RE: *Grading and Drainage Certification for Quail Pointe Subdivision (G11/D55)*
Engineer's Certification Stamp Dated 6/18/98.

PROJECT TITLE: Quail Pointe Subdivision

**RE: Grading and Drainage Certification for Quail Pointe Subdivision (G11/D55)
Engineer's Stamp Dated 5/7/98.**

**RE: QUAIL POINTE SUBDIVISION (G11-D55). DRAINAGE REPORT FOR
PRELIMINARY PLAT APPROVAL. NO ENGINEER'S STAMP ON GRADING PLAN.**

TYPICAL LOT PLAN

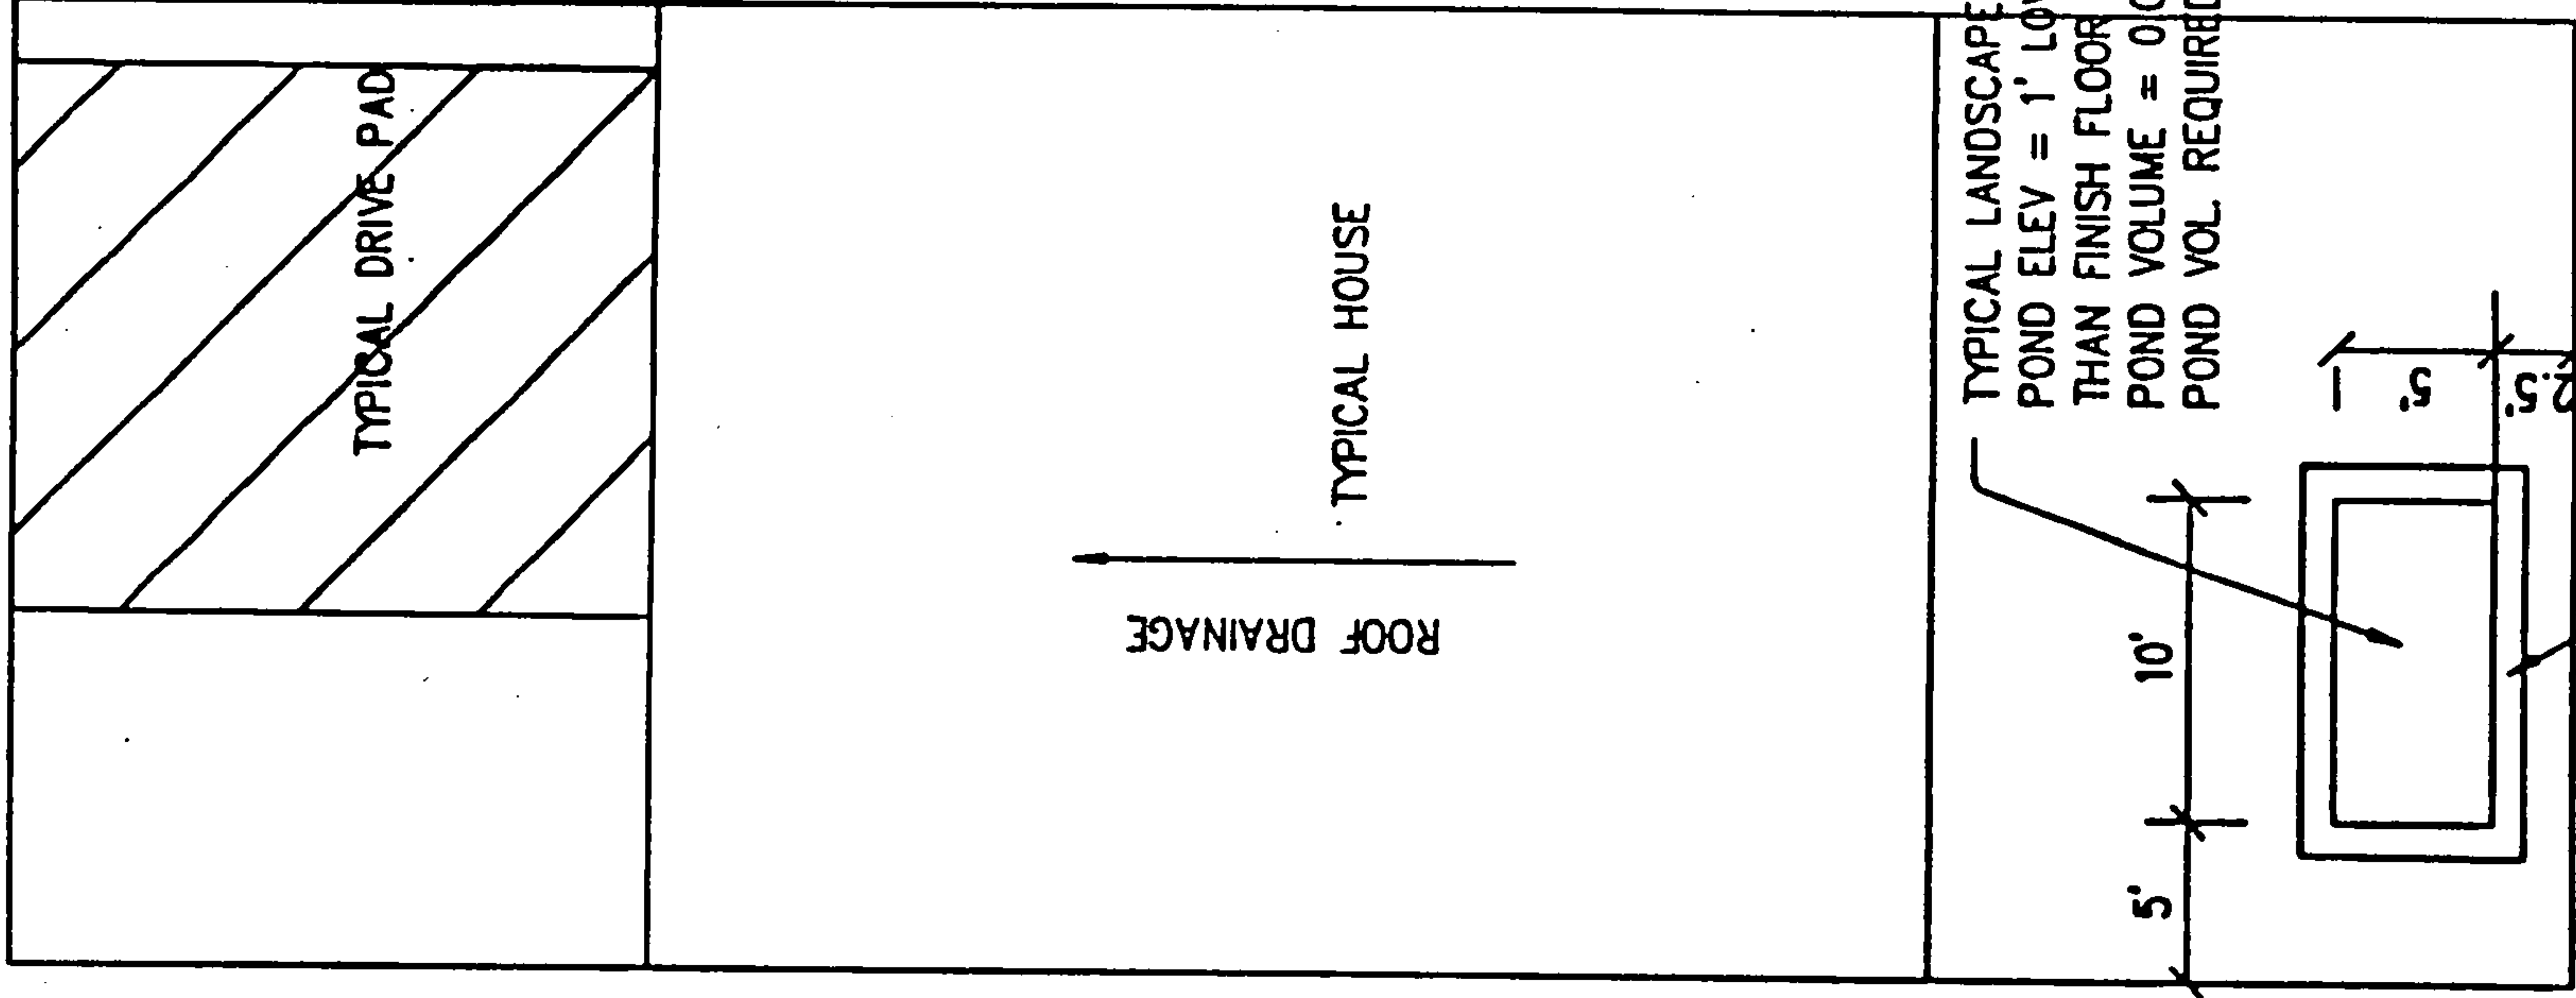
1. Preliminary Plat requires grading plan approval. The grading plan submitted with this package is too conceptual. Show more proposed spot elevations; a typical lot grading plan; finish floor/pad to mean sea level; and roof drain locations. Be certain to discuss how the back yards will drain.

1. Agreed - Attached please find a new grading plan with much more detail, including spot elevations, lot grading play, finish floor (MSL) and roof drain locations.
